Network Video Recorder

Version: V4.50.000 build210125

Release Note

Firmware Basic Information	Firmware Version:	V4.50.000 build210125
	SDK Version:	V6.1.6.5_build20201028
	Play Library:	V6.0.0.5
	Web component:	V4.0.1.1build201209
	OpenSDK Version:	V2.1.4

1. 【Local GUI menu operation optimization】

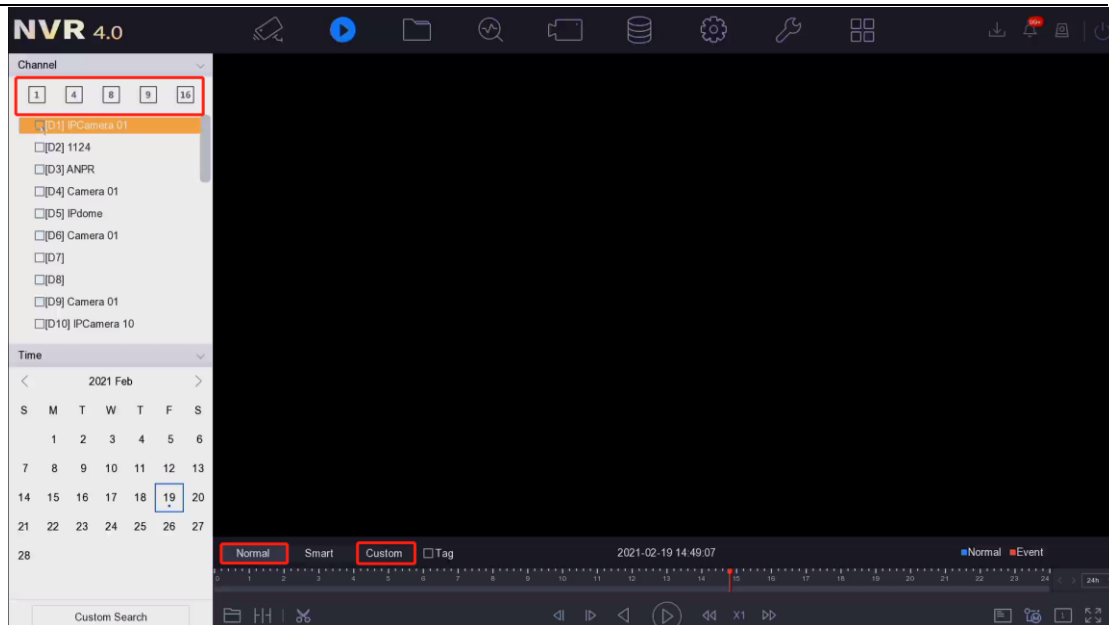
- 1) Local Live View supports shortcut operation of right-click menu. The specific menu options are: Single-screen selection; Multi-screen selection; Previous screen; Next screen; Start/stop Auto-switch; Add IP channel; Playback; PTZ control; Full screen/Main menu

- 2) Local normal playback and custom playback support channel group selection function.

- 3) The progress bar supports mouse wheel control when playing back video, and the left mouse button is used for positioning.

- 4) Remove the double progress bar, the progress bar only displays the video distribution of the currently selected channel.

2. 【N+M function】

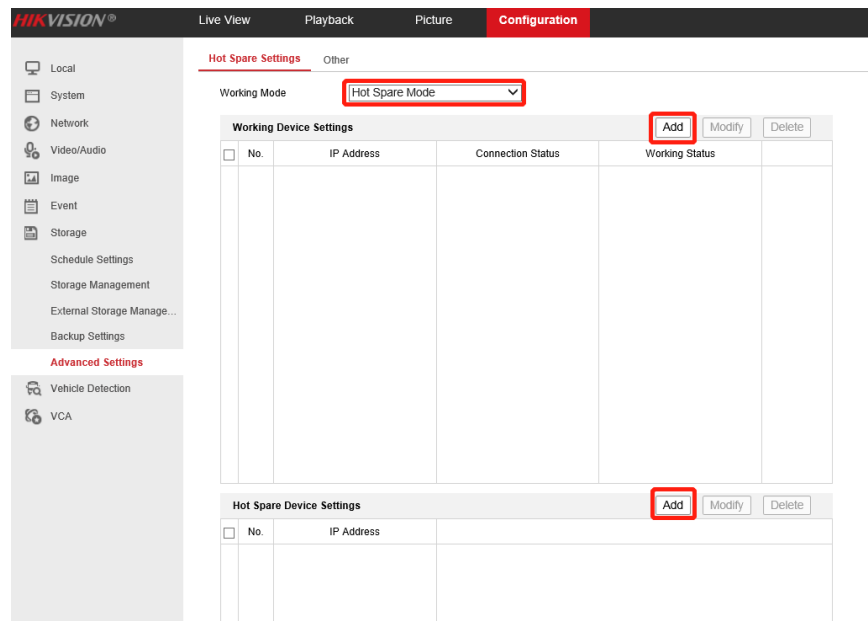
- 1) N+M system hot backup is to solve the scenario where multiple working machines fail at the same time, it supports adding up to 32 working machines and 32 hot backup machines.
- 2) The hot standby NVR can automatically take over the offline working machine, and return the video after the working machine is restored.

- 3) Compatible with the original N+1 function, the original local N+1 configuration menu is modified to the N+M configuration menu, the N+M menu is added on the WEB, and only the N+1 configuration menu is retained on the 4200.
- 4) On the basis of the existing N+1 environment, other hot standby machines can be added to the hot standby machine to form an N+M system.

6. 【Add the hardware version number on the local GUI】

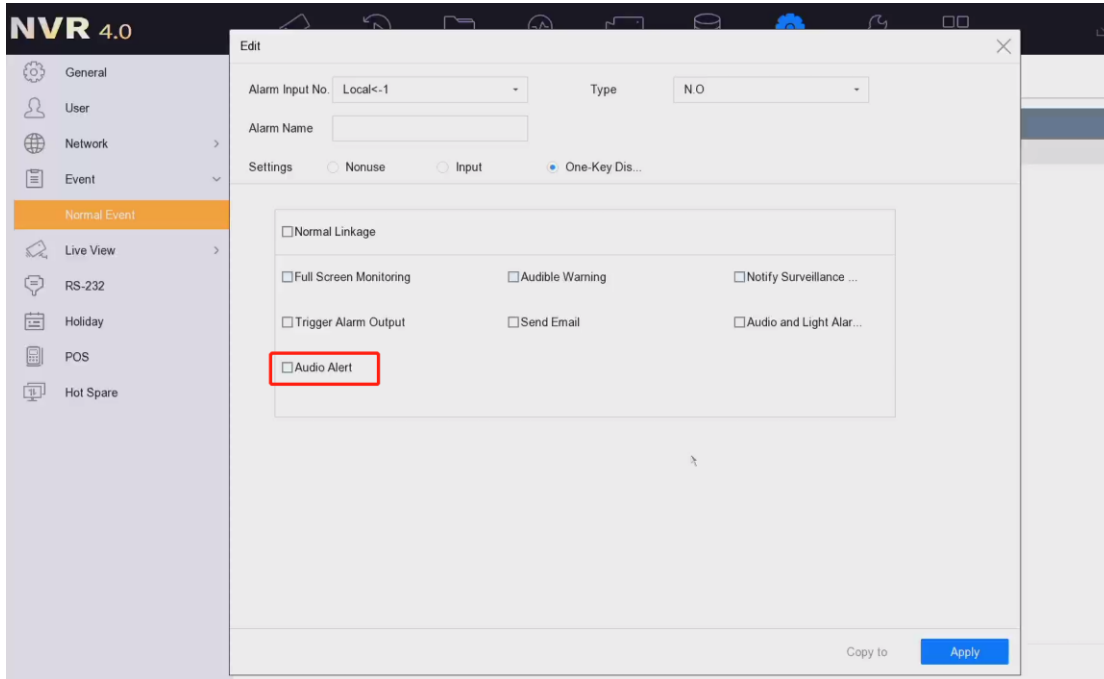
The local GUI adds the hardware version number to distinguish the devices of the same model with different motherboards.
